Car Stereo
Service Bulletin

Model: XES-P1/X1

No. 274

Subject: System Does Not Turn On If Long (18')
Unilink Cable Is Used.

DISPLAY BOARD XES-P1

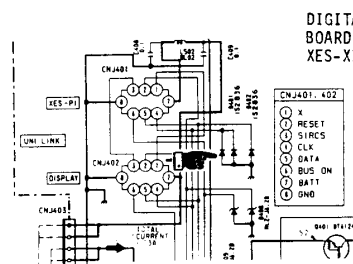
The system may not turn on if a long (18') Unilink cable is used between the XES-X1 crossover and the display unit or the hideaway unit (or both).

Add RB100A diodes in parallel with D-604 on the XES-P1 DISPLAY board and D-401 on the XES-X1 DIGITAL board.
